MEYLE-HD: Better than OE.  
**Improved bushing design**

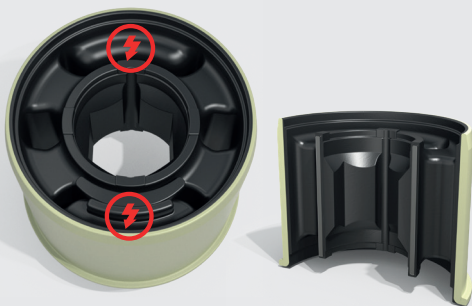
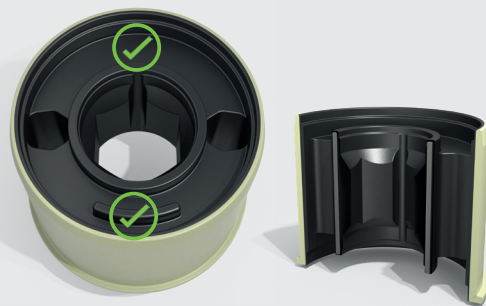
**Problem**

- Failure of the bushing due to intense strain

**Effect**

- Cracks in the rubber material
- Impaired driving safety

**Solution**

- Optimized design reduces stress in critical areas

**Advantage**

- Significantly longer lifetime due to less cracks in the rubber material
- Longer driving safety
- 4-year warranty
